VILLAGE OF DOWNERS GROVE
REPORT FOR THE VILLAGE COUNCIL WORKSHOP
AUGUST 11, 2009 AGENDA

SUBJECT:	TYPE:	SUBMITTED BY:
Façade Improvement Grant for 5150 Main Street	Resolution Ordinance ✓ Motion Discussion Only	Tom Dabareiner, AICP Community Development Director

**VILLAGE OF DOWNERS GROVE
REPORT FOR THE ARCHITECTURAL DESIGN REVIEW BOARD
JUNE 25, 2009 AGENDA**

SUBJECT:	TYPE:	SUBMITTED BY:
ADRB-07-09 5150 Main Street	Façade Improvement Grant	Stan Popovich, AICP Planner

EXTERIOR ELEVATIONS

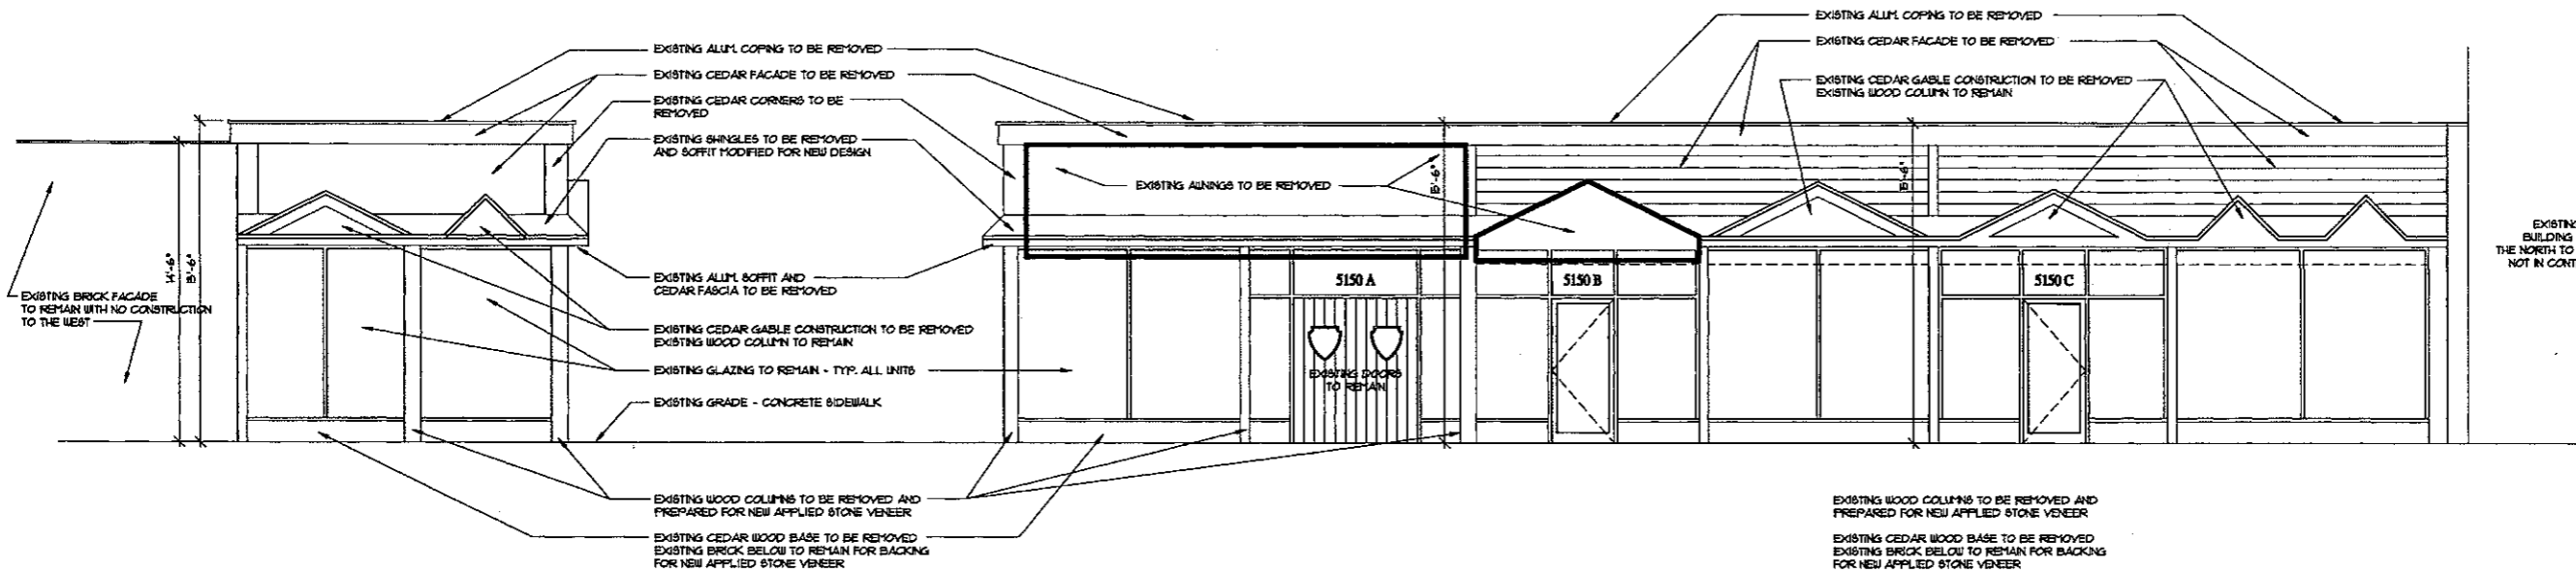
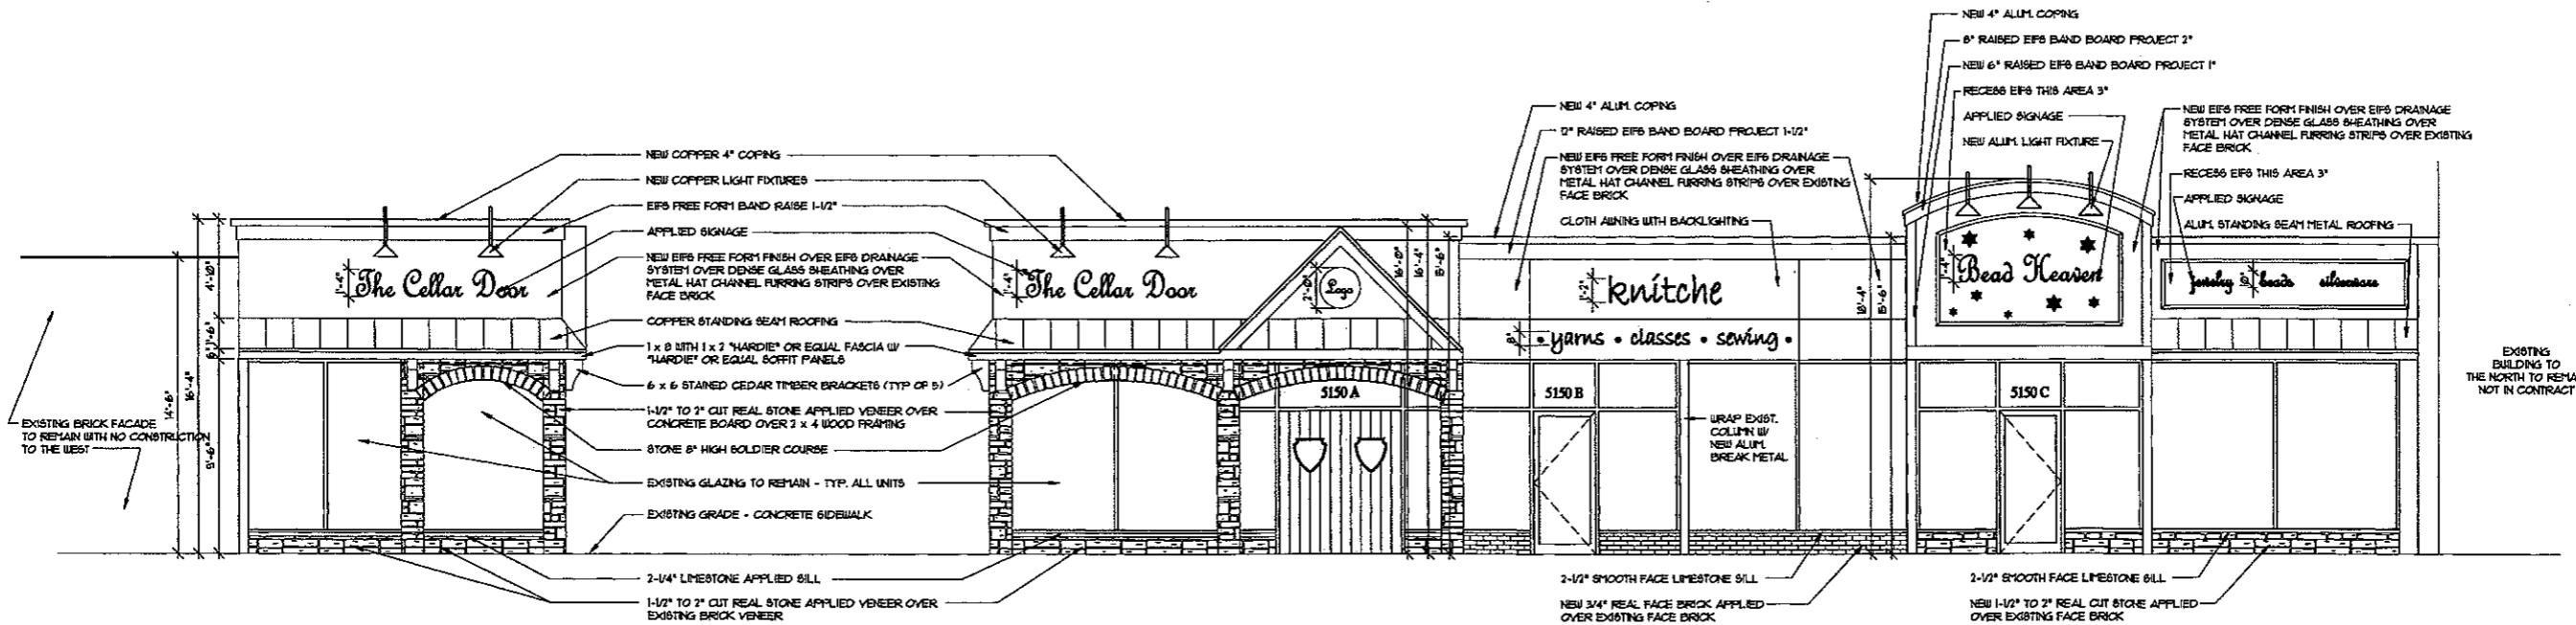
As shown, the proposed signage and backlit cloth awning does not meet the Village's Sign Ordinance. The proposed signage on the south façade is not allowed and the total square footage for each tenant exceeds the allowable amount.

The proposed EIFS façade relates to the adjacent bank building but does not relate to the brick buildings across Main Street. The original windows will remain and the existing features will be enhanced through improved building materials. Preferred and discouraged materials are used evenly throughout the building. Cut stone and brick make up the base of the building while EIFS is the primary material above the windows. The applicant is proposing two standing seam awnings and one back-lit awning. Standing seam and backlit awnings are not appropriate for the downtown business district. Protruding light fixtures are provided above the signage for units A and C.

Projecting signs are not provided. It should be noted that the proposed signage, while not in the purview of the design guidelines, does not meet the Village's Sign Ordinance. The proposed signage will have to be modified to comply with the Ordinance.

1. The applicant shall apply for a building permit prior to the commencement of construction activities. The proposed construction shall comply with all applicable building codes.
2. The applicant shall apply for a separate sign permit for all proposed signage. The proposed signs shall comply with the Village's Sign Ordinance.
